Update to stassar_3ct_01a_201116.pdf, Related to comments # i-42 and # i-65

IEEE P802.3ct Task Force, Interim Teleconference, 3 December 2020

UPDATED Proposal for revised Table 154-10, black link

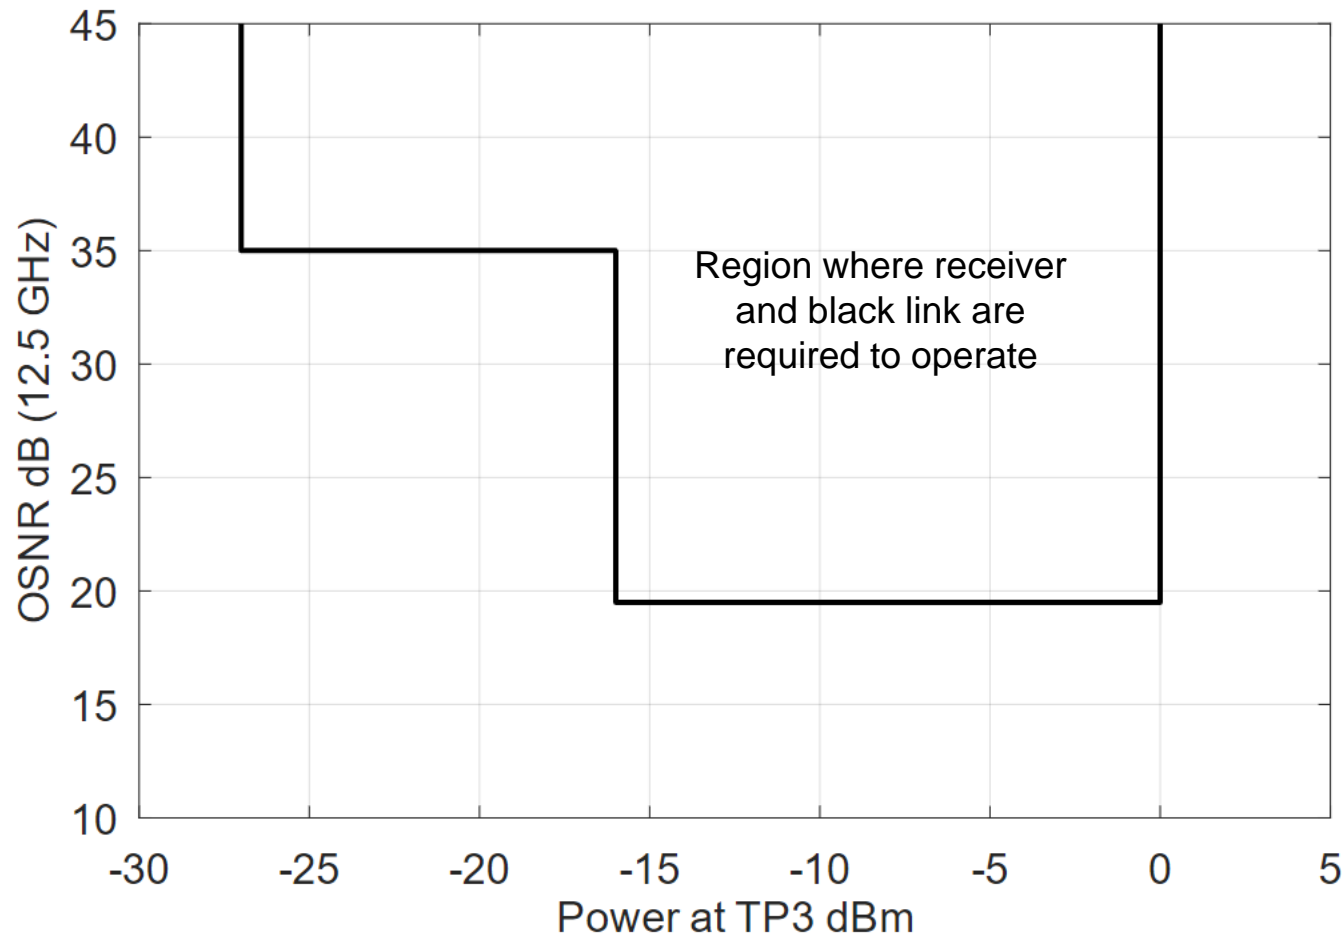
Change -29 dBm to -27 dBm

Change 1 dB to 3 dB

Remarks have been made that an optical penalty of 3 dB for OSNR ≥ 35 dB (12.5 GHz) is a better starting value than 1 dB, proposed in https://www.ieee802.org/3/ct/public/20_11/stassar_3ct_01a_201116.pdf

<u>Average output power at TP3 (max)</u>	<u>0</u>	<u>dBm</u>
<u>Average output power at TP3 (min):</u> <u>for OSNR at TP3 < 35 dB (12.5 GHz)</u> <u>for OSNR at TP3 ≥ 35 dB (12.5 GHz)</u>	-16 -27	<u>dBm</u> <u>dBm</u>
<u>OSNR at TP3 (min)</u>	<u>19.5</u>	<u>dB (12.5 GHz)</u>
<u>Optical path OSNR penalty (max),</u> <u>for OSNR at TP3 < 35 dB (12.5 GHz)</u>	3	dB
<u>Optical path penalty (max),</u> <u>for OSNR at TP3 ≥ 35 dB (12.5 GHz)</u>	3	<u>dB</u>
